**FRAMATOME ANP, Inc.**

April 4, 2003  
NRC:03:011 Rev. 1

**Downcomer Boiling in Framatome ANP PWR ECCS Evaluation Models**

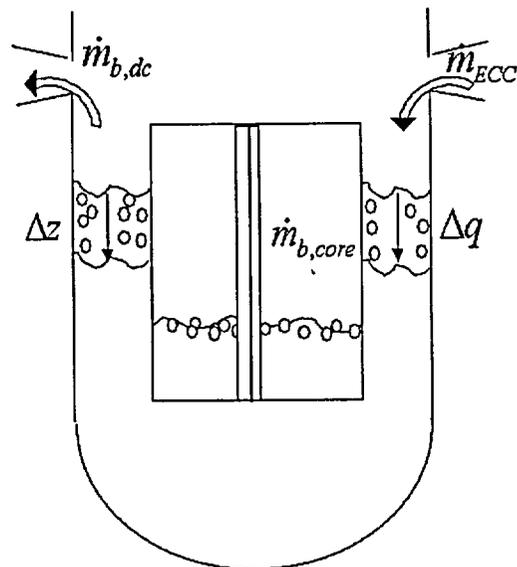
**Question 27:** *The brief overview and description of large break LOCA behavior on Page 3-4 does not mention the potential for downcomer boiling. Downcomer boiling has been shown to be important in the transport of coolant to the core in the LBLOCA. Discuss the basis for the applicability of the S-RELAP5 simulation of the effects of downcomer boiling and the manner in which downcomer boiling has been treated in the RLBLOCA methodology. Include in the discussion the roll of the downcomer wall initial temperature in downcomer boiling.*

*The PIRT in Table 3.3 does not include downcomer boiling. Please include in the discussion the exclusion of downcomer boiling from the PIRT.*

Hot downcomer walls penalize PCT by two mechanisms: reducing subcooling of coolant entering the core and by the loss of coolant mass out the break from boiling along the downcomer ( $\dot{m}_{b,dc}$ , see figure at right). These processes reduce the density of the downcomer fluid and effectively lower the height of the liquid column in the downcomer which reduces the pressure driving force for reflooding the core. While boiling in the downcomer may occur at anytime during a LBLOCA transient, the biggest impact on clad temperatures will occur during late

reflood following the end of accumulator injection. At this time, there is a large step reduction in coolant flow from the ECC system ( $\dot{m}_{ECC}$  in figure) and, at this same time, the coolant subcooling is being lost due to heat input from the downcomer metal mass. When this coolant becomes saturated, boiloff occurs which further reduces the effective downcomer level. With the reduction of the downcomer liquid level, the core reflood rates will be reduced and the clad temperatures will increase.
